UNITED STATES PATENT AND TRADEMARK OFFICE

APPLICATION NO.	FILING DATE	FIRST NAMED INVENTOR	ATTORNEY DOCKET NO.	CONFIRMATION NO.
10/080,754	02/22/2002	Gerald W. Fly	8540G-000058	9350

Office Action Summary	Application No.	Applicant(s)	
	10/080,754	FLY ET AL.	
	Examiner	Art Unit	
	Carol Chaney	1745

FIG. 2

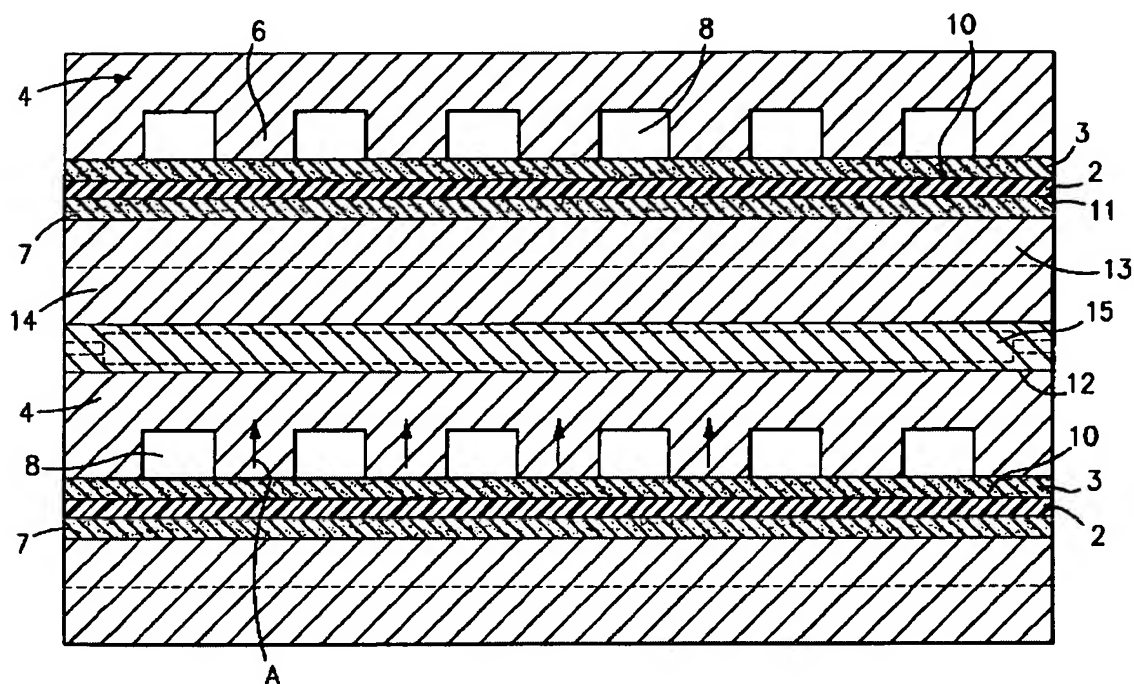
Cipollini discloses a solid polymer membrane fuel cell which includes a membrane electrode assembly having a membrane (2), with a first catalytic layer (3) on a first face of the membrane, and a second catalytic layer (7) on a second face of the membrane. Bipolar plate assembly (13, 14) is adjacent the anode catalytic layer (7) and is in electrical contact with the catalytic layer. The surface of the anode gas flow field plate (13) contacts a gas impermeable member (14). See Cipollini, column 5, lines 31-34.) Thus, layer 14 is nonporous and gas impermeable. The bipolar plates, reference 4 and references 13 and 14 include gas distribution layers having a plurality of highly porous reactant gas flow channels (8) or (13) which extend transversely through the gas distribution layers, in generally parallel orientations. (See Fig. 2.) Clearly, the

porous reactant gas flow channels (8) are in fluid communication with catalytic layer (3).

The presence of water in "transfer member" or bipolar plate assembly (4) prevents cathode reactant gas from migrating from the gas passages through the transfer member. (See Cipollini, column 5, lines 51-54.) Thus, the upper layer of plate 4 is impermeable to cathode reactant gas.
